**SUBJECT: COMANCHE PEAK STEAM ELECTRIC STATION (CPSSES)
DOCKET NO. 50-446
UNIT 2 INSERVICE INSPECTION (ISI) A-4 THROUGH A-8 RELIEF
REQUESTS FROM 1986 EDITION OF ASME CODE, SECTION XI,
NO ADDENDA**

**ADDITIONAL INFORMATION REQUESTED FOR UNIT 2
INSERVICE INSPECTION (ISI) A-4 THROUGH A-7
RELIEF REQUESTS FROM 1986 EDITION OF ASME
CODE, SECTION XI, NO ADDENDA**

**TXU GENERATION COMPANY LP
COMANCHE PEAK STEAM ELECTRIC STATION UNIT 2
FIRST TEN-YEAR INTERVAL ISI RELIEF REQUEST NO. A-7**

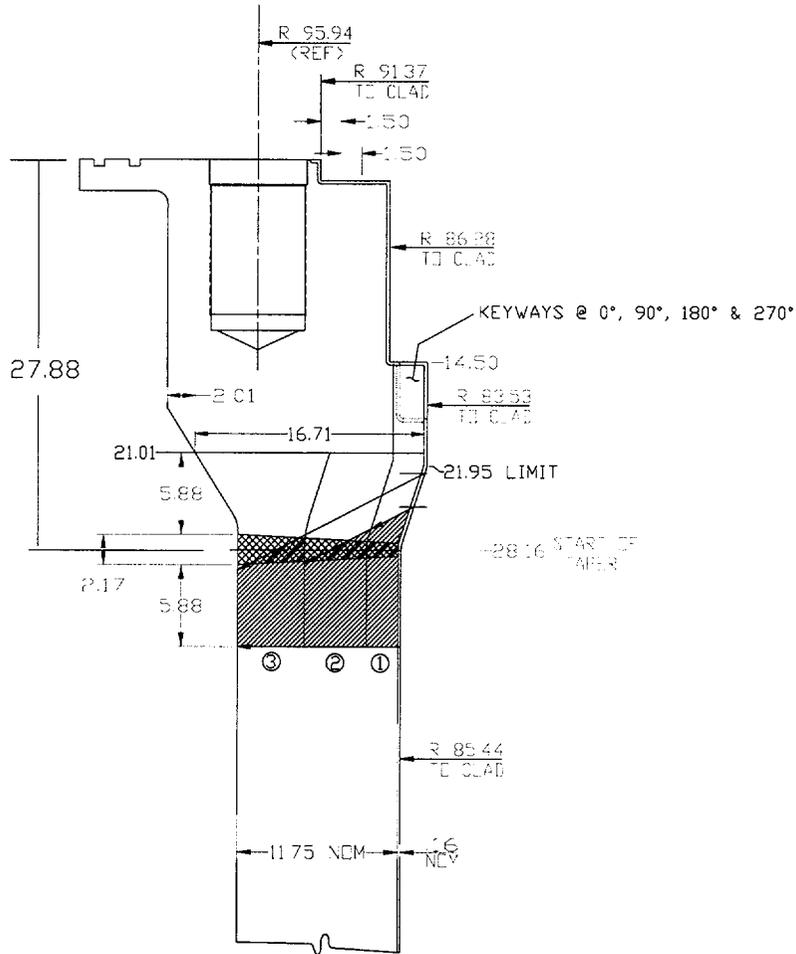
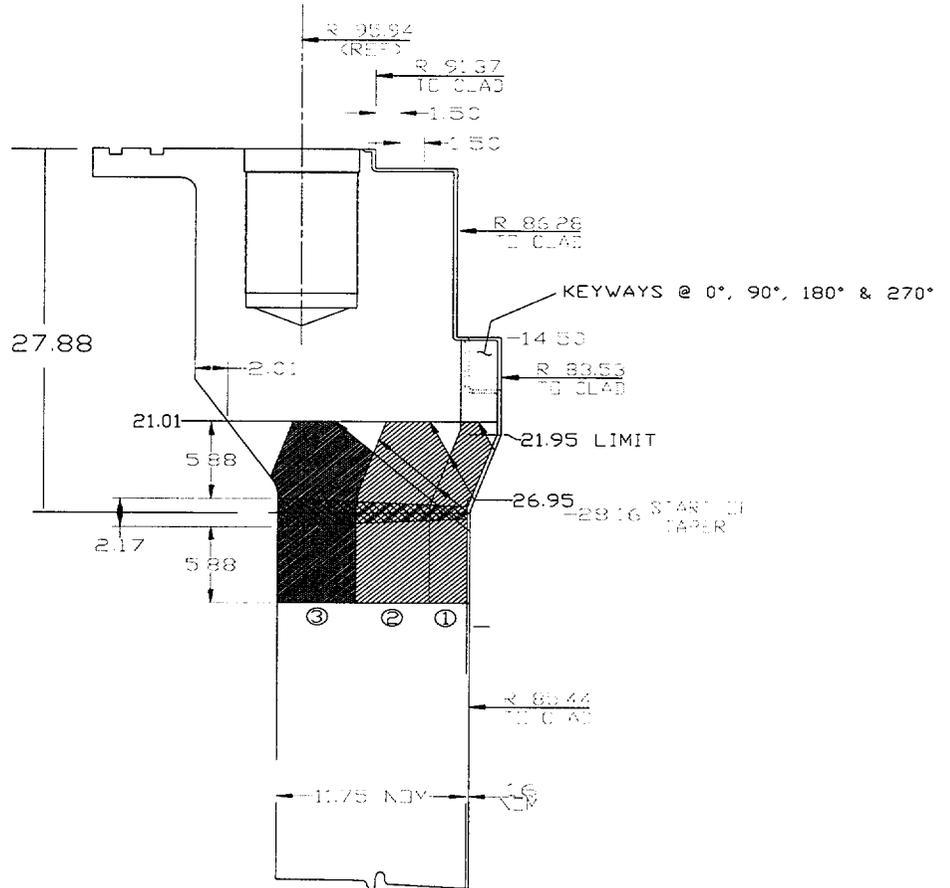
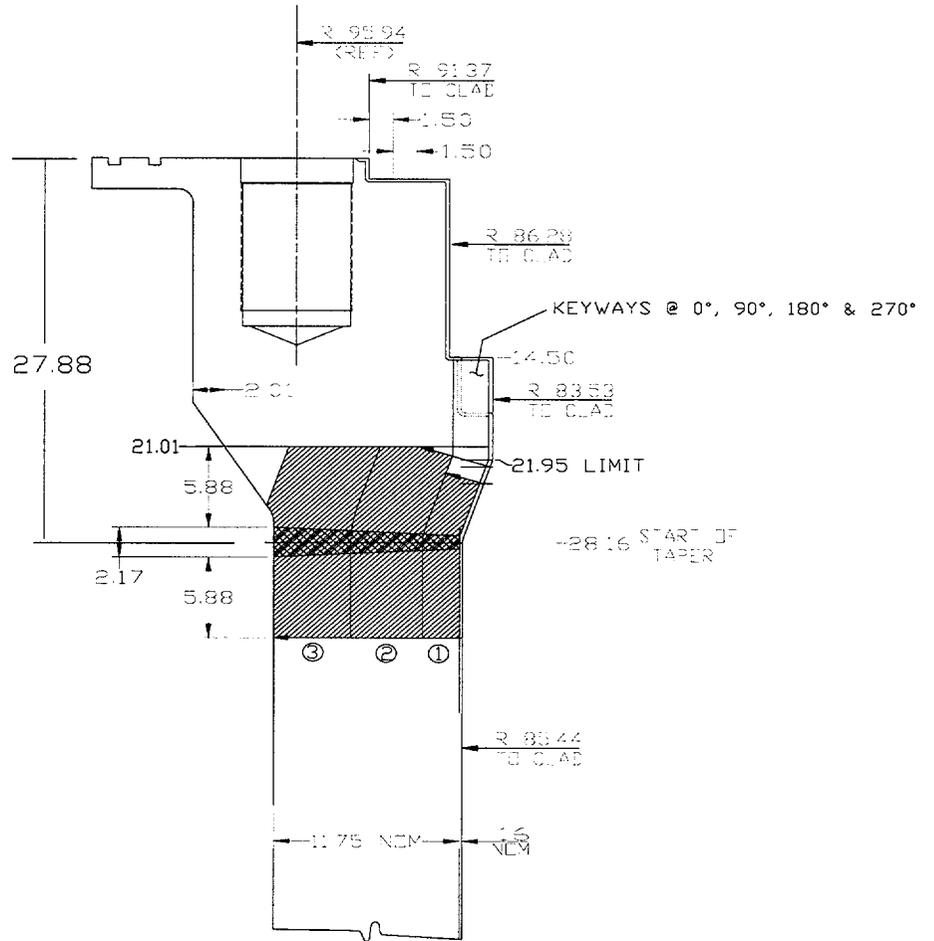
- B. Is the weld accessible to examination from all scan directions? Provide drawing(s) showing access from all scan directions? Is the licensee able to examine the weld on both sides?

Yes, refer to Figures 1 through 3.
